STAFF REPORT
KETCHUM PLANNING AND ZONING COMMISSION
MEETING OF SEPTEMBER 15, 2020

PROJECT: 4th & Walnut Ave Commercial Development Design Review

FILE NUMBER: P20-046

APPLICATION TYPE: Design Review

NOTES AND DETAIL SHEET
4TH AND WALNUT
 LOCATED WITHIN SECTION 18, T.4 N., R.18 E., B.M., CITY OF KETCHUM, BLAINE COUNTY, IDAHO
 PREPARED FOR WALNUT & FOURTH LLC

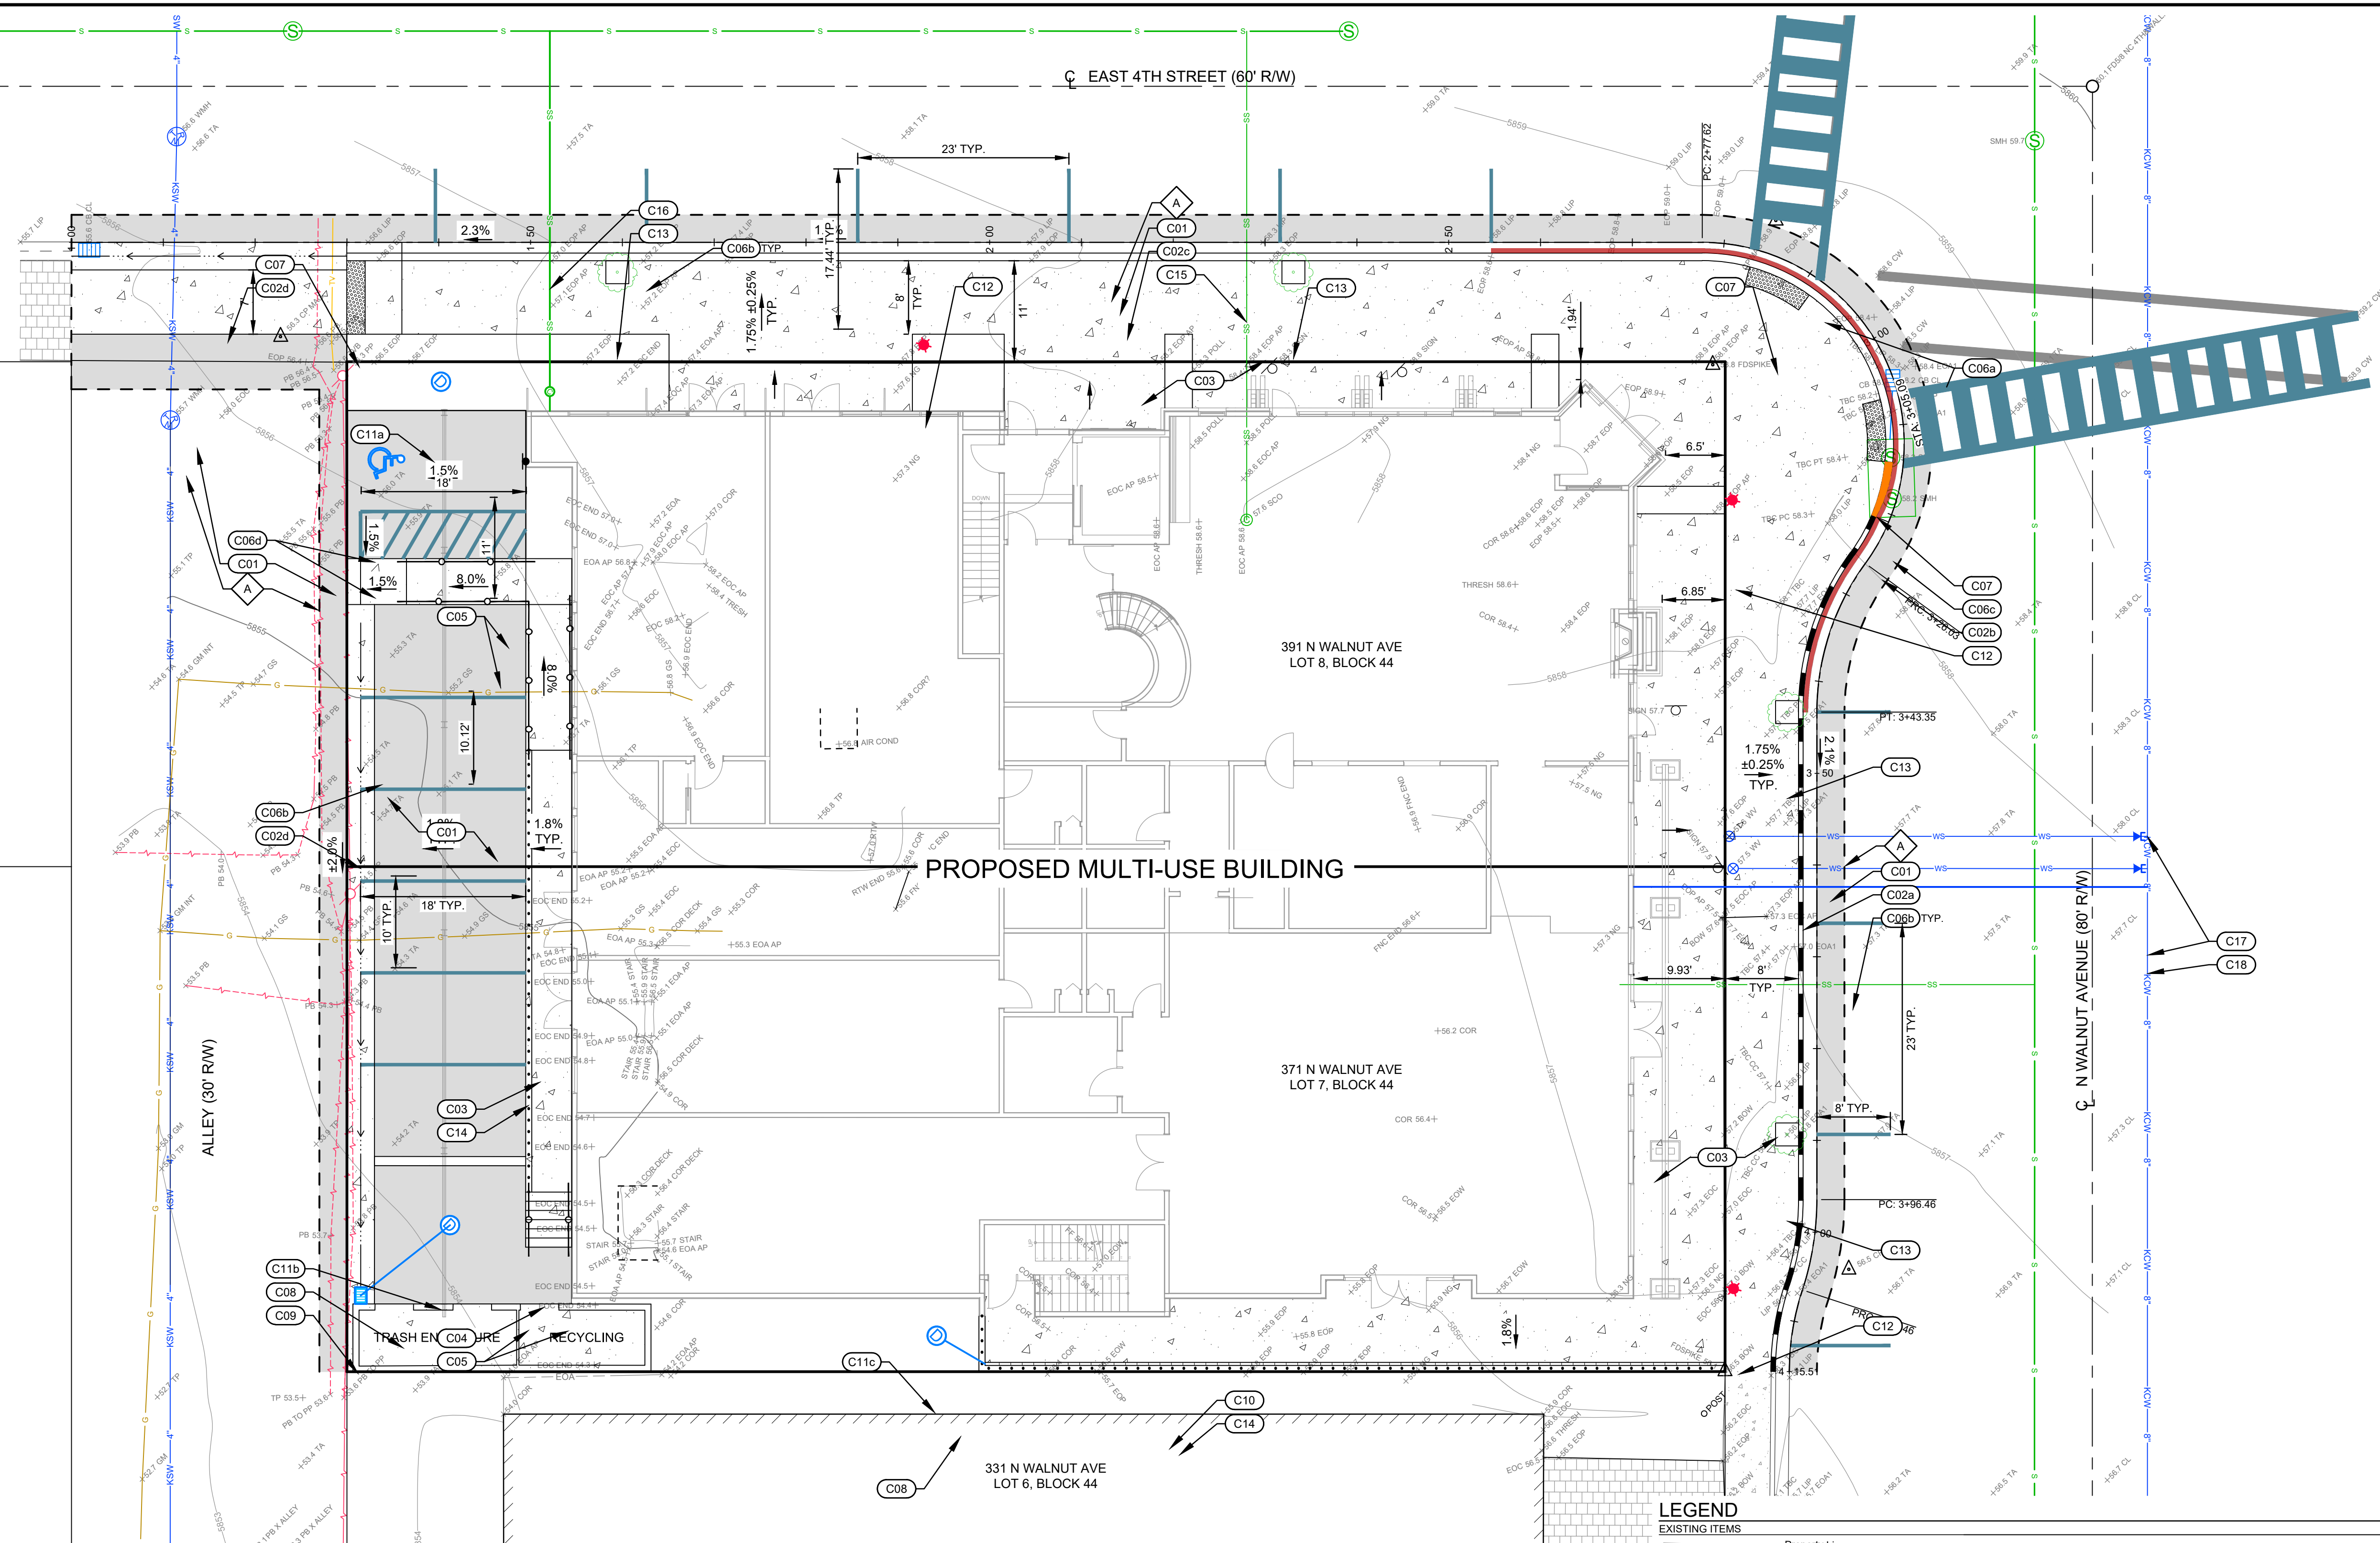
| | | | <i>Staff Comments</i> | <p><i>All storm water shall be retained on site, including storm water from roof drains. Sheets C1.1, C0.1, and C0.2 of the project plans attached as Exhibit A indicate the proposed drainage improvements.</i></p> <p><i>Roof drain locations and specifications must be indicated the project plans submitted with the building permit application for review and approval by the City Engineer and Streets Department.</i></p> <p><i>Prior to issuance of a building permit for the project, the applicant shall submit a final drainage plan indicating grading, catch basins, piping, and drywells (KMC §17.96.040.C.2b & KMC §17.96.060.C.1-4) prepared by a civil engineer licensed in the state for review and approval by the City Engineer and Streets Department. See Table 1 for City Department comments including City Engineer and Streets Department conditions.</i></p> |

DEMOLITION LANDSCAPING PLAN

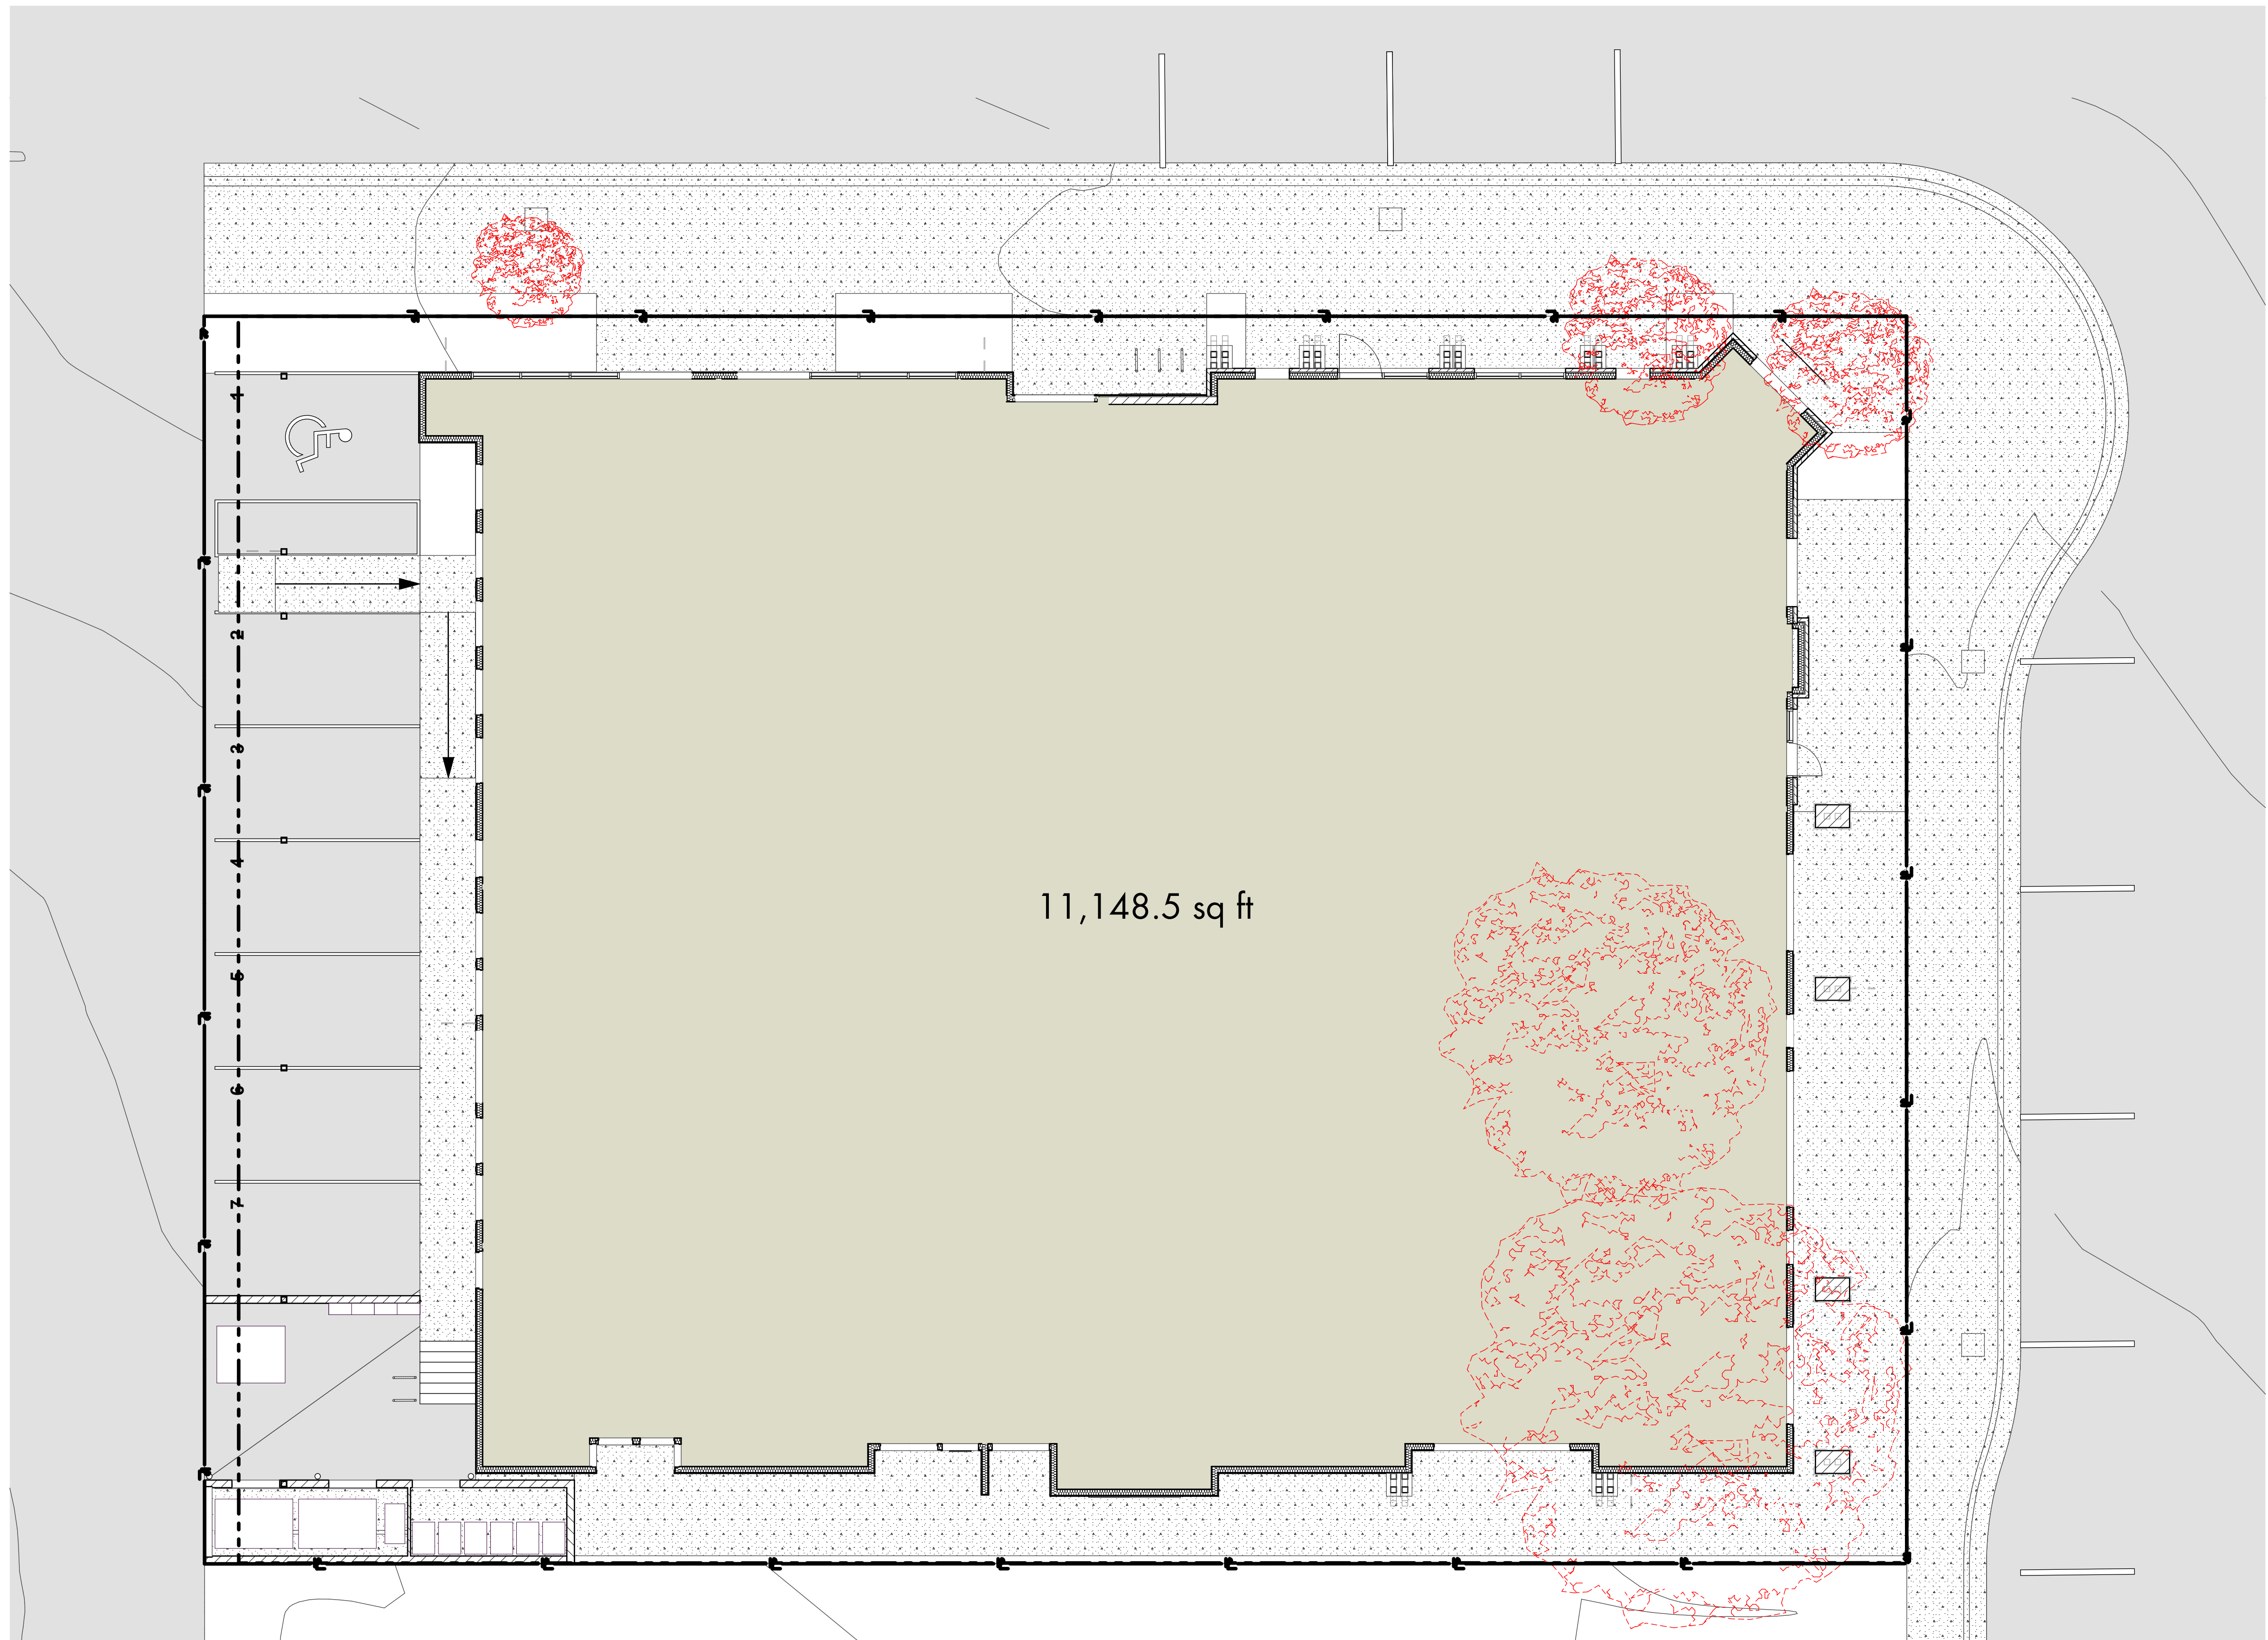
| | | | Staff Comments | <p>The Demolition Landscaping Plan on Sheet L-1 indicates that 5 mature trees will be removed from the project site to accommodate the new development.</p> <p>The applicant has proposed four street trees within the ROW along Walnut Avenue and 4th Street. Street trees may be considered if a snowmelt system is installed for the sidewalks. Streetscape improvements must be indicated on civil plans submitted with the building permit application for final review and approval by the City Engineer and Streets Department. If approved by the City Engineer and Streets Department, all encroachments within the ROW require an Encroachment Permit.</p> <p>The applicant shall coordinate with the City Arborist regarding the placement of off-site replacement trees. The siting of the 5 replacement trees shall be finalized on the project plans submitted with the building permit application for review and approval by the City Arborist, the City Engineer, and the Streets Department. The installation of the 5 replacement trees shall be verified upon final</p> |
